STAFF REPORT

To: Lemoore City Council & Planning Commission
From: Holly Smyth, Planning Director
Date: December 29, 2010
Subject: Examples of Site Plan Review since the 2030 General Plan Adoption

SITE PLAN REVIEW & PARCEL MAP APPLICATION FOR DAVITA DIALYSIS CENTER – APPROVED BY PLANNING COMMISSION

Elevations Approved by Planning Commission

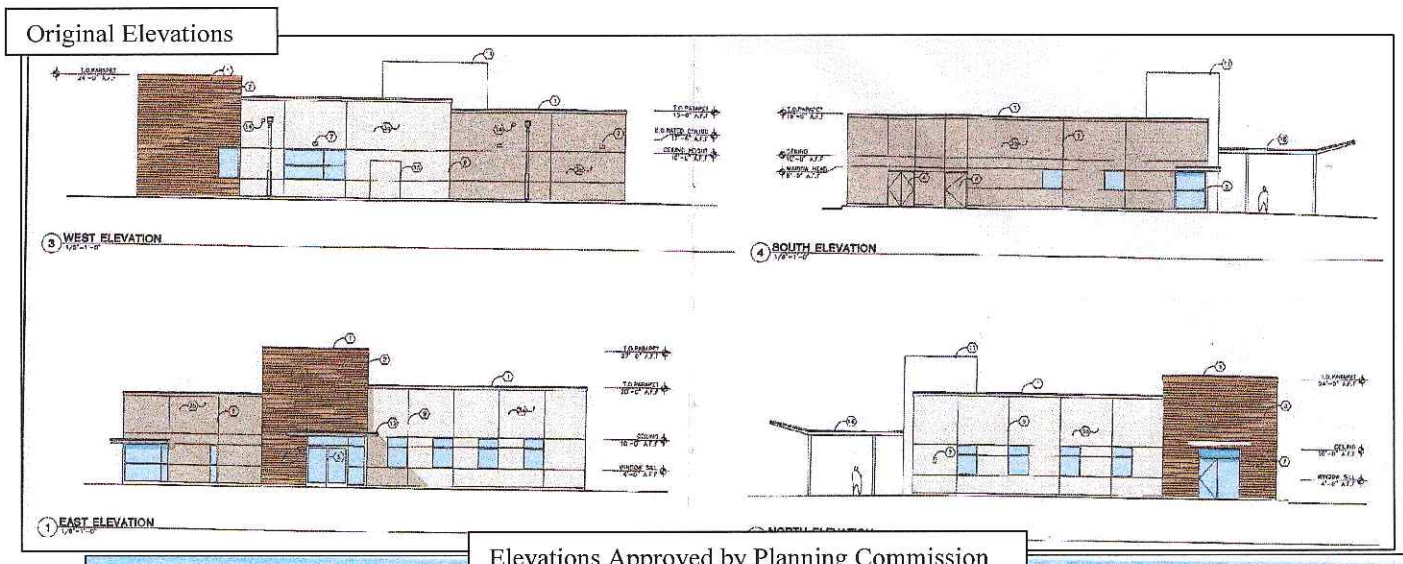
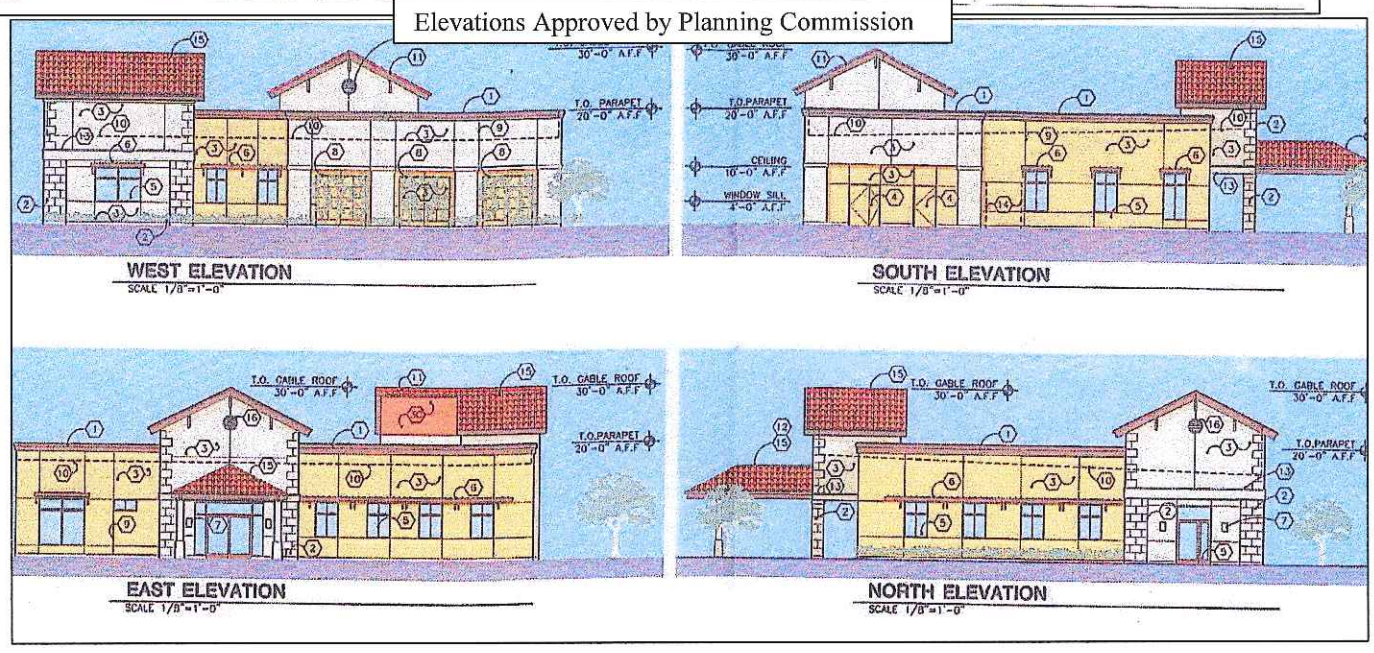
- 6,300 square foot building
- Site Plan Review could have been done administratively by staff if Parcel Map not involved
- General Plan (GP) policy CD-I-34 "require(s) design of building in neighborhood centers to be consistent with Lemoore's small town character" and further addresses style, color, height, and landscape that should be incorporated.
- GP policy CD-I-36 "required continuous street frontage" with "no building setback from street unless a canopy or roof structure provided to maintain continuous sidewalk" as well as incorporating "centrally-located pedestrian access" which was accomplished with a pedestrian trellis versus building next to landscape buffer area shown on the Site Plans below
- Building canopy was not required by Planning but was part of Building Code for the type of use

Draft Overall Site Plan for entire shopping center done by staff to determine circulation adjacent to City streets

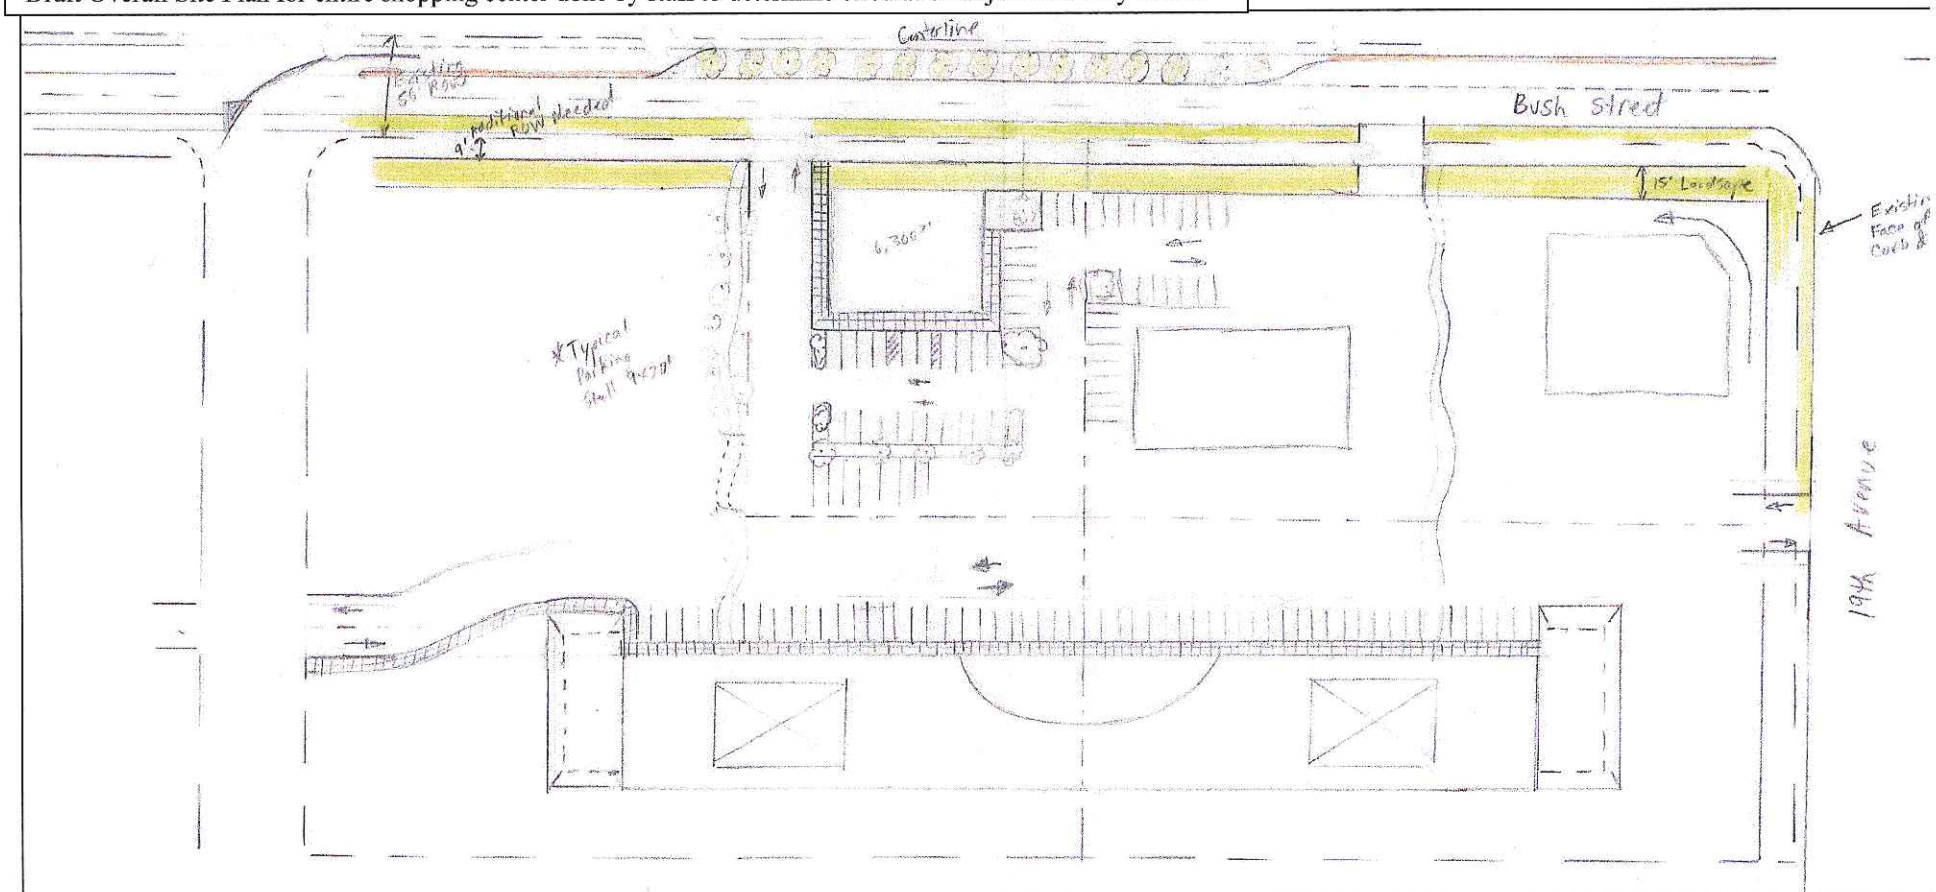
- Deferment allowed for median, paveout, bikelane, curb, gutter, parkway, and sidewalk as these improvements would be problematic in the near term across just this site. However, 8' right-of-way dedication and 10' public utility easements required to be given to the City prior to occupancy.
- GP goal **C-G-4** states "maintain acceptable levels of service and ensure that future development and the circulation system are in balance." This requires staff to review overall layout of entire shopping center to identify permanent long-term access points into the shopping center and ensure the flow within the shopping center will work in future years with the proposed near-term development.
- Flexible conditions put in place to allow for "cross-access" for utilities if the developer could get from adjacent property owner to reduce the lineal footage of utilities and thereby the costs

Original Elevations with redlined approvals incorporated

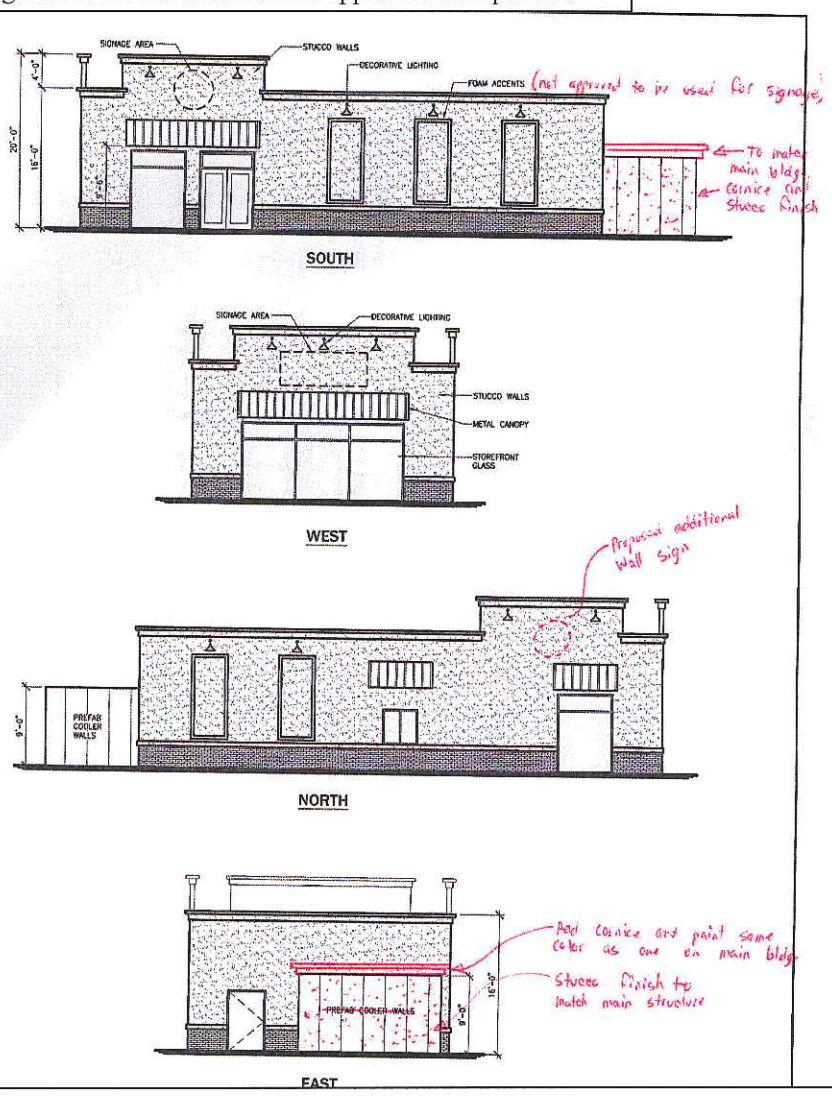
- General Plan goal CD-G-2 states "enhance key city entrances on primary vehicular corridors". Therefore trash enclosure that was going to be visible to incoming traffic enhanced to have a stucco coat over the blocks and add a cornice topper to match the main building structure.

Redlined Site Plan approved by Planning Director

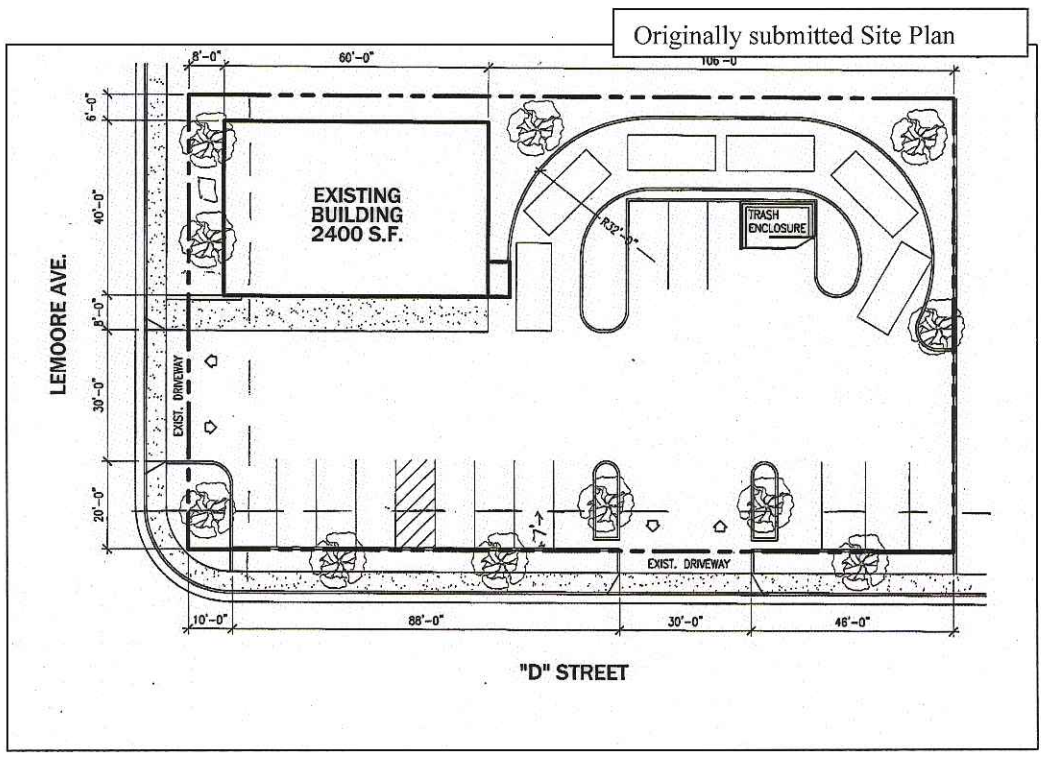
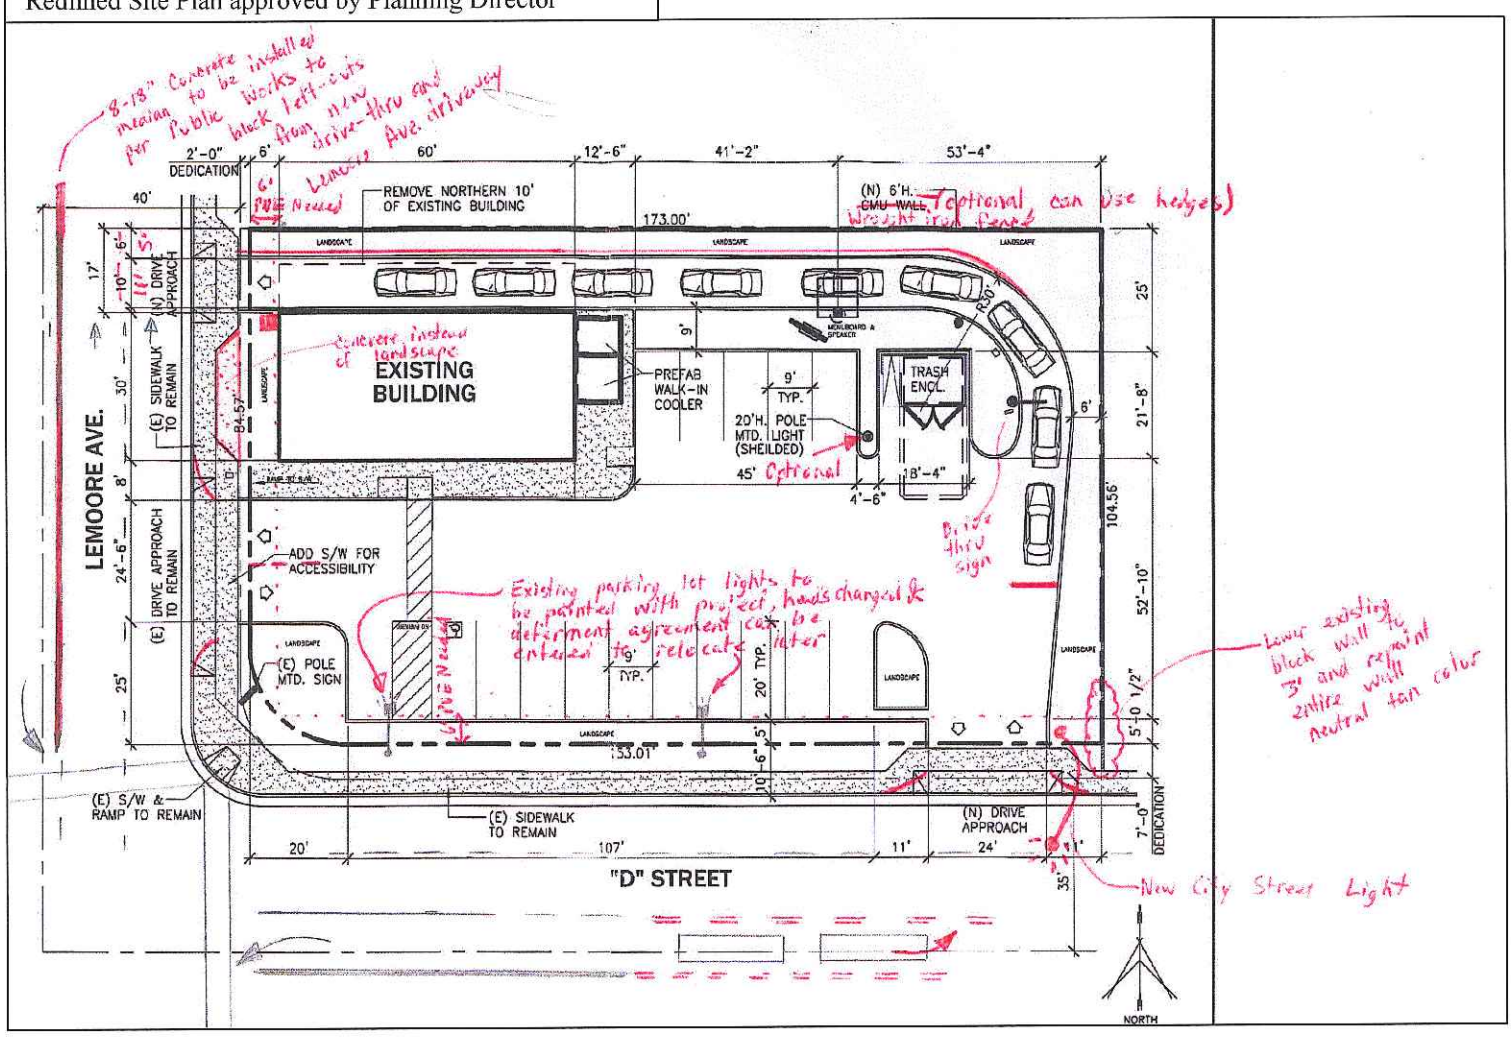
- Project involved converting 2,400 sq ft existing retail building (the old Auto Zone) into an 1,800 sq ft restaurant with drive-thru
- Original Site Plan layout fit less than 10 cars in the drive-thru with awkward layout that had potential to backup onto "D" Street westbound as well as eastbound turn pocket. Staff asked draftsman to configure to allow for at least ten car stacking based on problems experienced at other drive-thru locations. Resubmitted site plan with the back 10' of the building removed to accommodate utilities and drive thru lane for 10 car stacking on-site, and move the "D" Street driveway easterly to allow some stacking in turn pocket to allow left-turn into site.

- GP goal **C-G-4** states "maintain acceptable levels of service and ensure that future development and the circulation system are in balance." GP policy C-I-1 states "adopt street standards that provide flexibility in design,….and revise right-of-way standards where necessary….*some existing areas may require additional right-of-way to accommodate buildout traffic demand, or may be constrained by existing land use, which may limit the City's ability to meet the standards…".* GP policy C-I-2 "requires(s) all new development to provide right-of-way improvements consistent with the General Plan street designations and street cross-section standards…"Previous traffic study done for St. Peters church project showed most of Lemoore Avenue needing to be channelized to reduce left-turn traffic movements (which generally means the installation of concrete or landscaped medians in heavy traffic conflict areas). Additionally, per General Plan Figure 4-4 shows "D" Street in front of the project as a future re-aligned Truck Route once adequate right-of-way is obtained. Median and right-of-way costs are not part of the impact fee program, nor do existing sites that are not adding additional building square footage subject to impact fees, therefore any traffic impacts caused by the "project" need to be addressed by the applicant directly.

- Based on the above policies and given the constraints adjacent to the site, right-of-way dedication of 7' along Lemoore Avenue and 2' along "D" Street prior to occupancy with existing monolithic sidewalks remaining but the improvements to the street will be handled with future City street widening projects which are included in the City's impact fee study. However, should the project cause traffic backups onto adjacent arterial streets in the future, the conditions of approval state the owner will need to resolve through one of many various options to keep initial project costs low. Concrete median required in Lemoore Avenue to avoid left-out from drive thru which would be a traffic hazard.

- General Plan policy CD-I-8 requires a 15-foot landscaped front setback area along all arterial and collector streets outside Downtown, as sites are developed or major renovations undertaken. 10' landscaping being incorporated in near term with future ability to remove 5' front portion of landscaping.

Original Elevations with redlined approvals incorporated

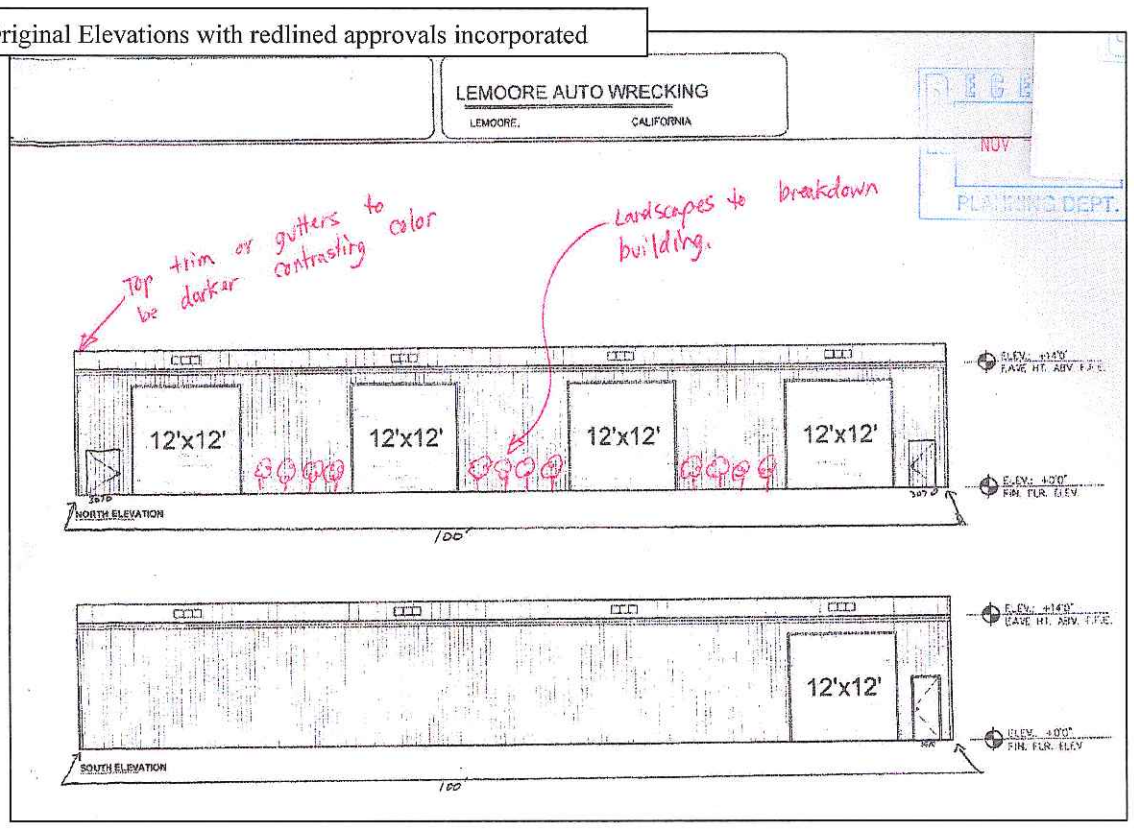
- General Plan (GP) policy CD-I-20 "ensure that non-residential building façades are visually attractive, with windows offering views into buildings and architectural articulation; prohibit large blank walls facing the street unless screened by landscaping. *These standards will be incorporated into the Zoning Ordinance and be applicable to all new development or major redevelopment along Iona Avenue.".* Therefore, landscaping added to northerly side of building foundation as well as westerly wall of building and colorized top trim/gutter of the building to incorporate contrasting color.
